GORT PUBLIC REALM ENHANCEMENT PROJECT

AN COIMISIUN PLEANALA CASE NO. 323066-25

**GALWAY COUNTY COUNCIL RESPONSE TO
OBSERVATION BY:**

J SULLIVAN & TTRSA

Extract from the submitted drawing DR-L-0103 illustrating the pedestrian priority access road, pedestrian crossing at the desire line, drop-off zone in front of Sullivan's Hotel, age-friendly parking, and the realigned junction at the R458 at Gort Market Square.

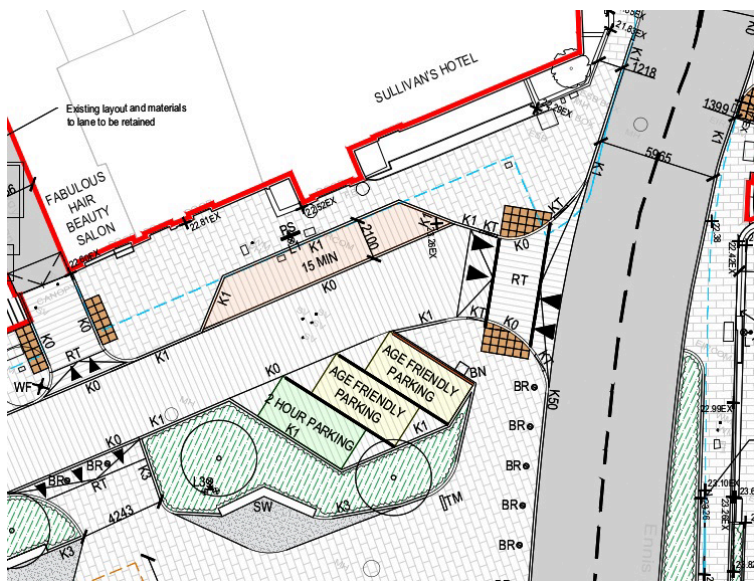
The current arrangement of the public parking to the front of Sullivan's Hotel eliminates the possibility for the provision of a pedestrian crossing on the desire lines posing a significant danger to all road users

The Galway County Council design proposal seeks to provide safe pedestrian access, manage traffic at the junction of the R460 and R458, and provide dedicated age friendly bays along a service access road which will incorporate passive traffic calming measures. In addition to this the realignment of the R460 to R458 junction in front of the hotel will make it safer for all road users. The dedicated access road is required by Sullivans Hotel delivery vehicles as they currently stop on the R458 (photo 2) which presents a serious danger to all road users as evidenced below.

Figure 2 Vehicle Movement Assumptions

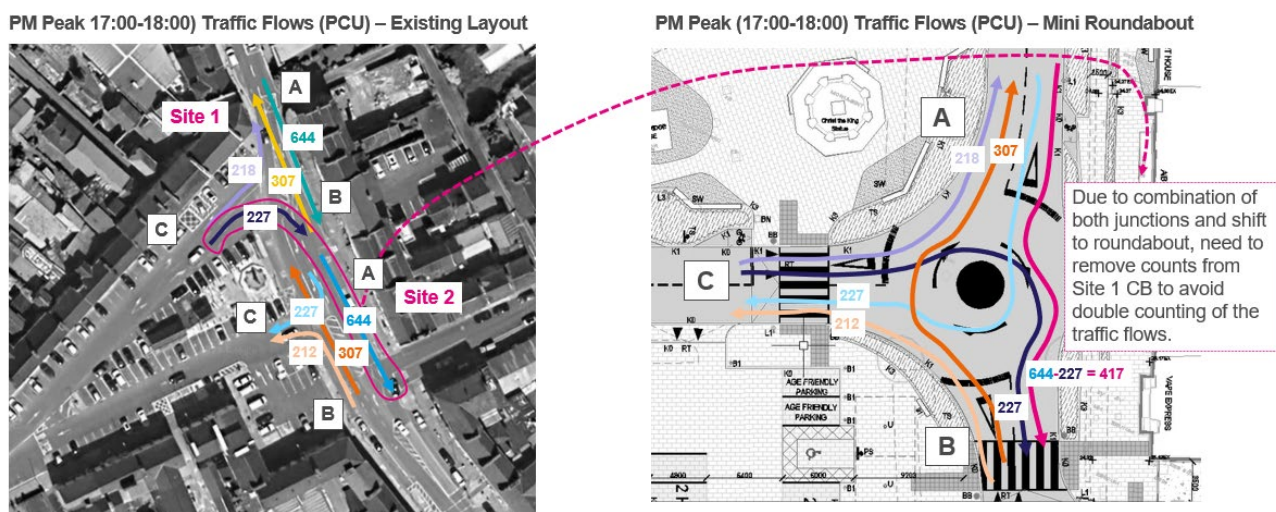
The TTRSA report suggests that the demand flows and traffic movements included with the traffic modelling do not reflect the entry flows and traffic movements contained within the traffic data included within Appendix B of the consultation, in particular for the AB movement. The numbers indicated by Momentum have been checked, and are correct. As the scheme proposes to combine the 2x existing junctions into a mini-roundabout, it is not possible to take the raw numbers from the 2x existing junctions and additional calculations are required to avoid the double counting of the vehicle flows on the Arm A to B movement. As can be seen in Figure 2 below, the Arm C to B turning movements on Site 1 (227 vehicles in the PM peak)

then needed to go through Site 2 and would also have been included in the Arm A to B movement (644 vehicles) on Site 2. With the introduction of the mini-roundabout, the Arm C to B movement at Site 1 will be made directly at the roundabout and should therefore not be counted as part of the Arm A to B movement at Site 2. This explains why 417 vehicles (644-227) has been used for the Arm A to B movement in the traffic modelling for the mini-roundabout.
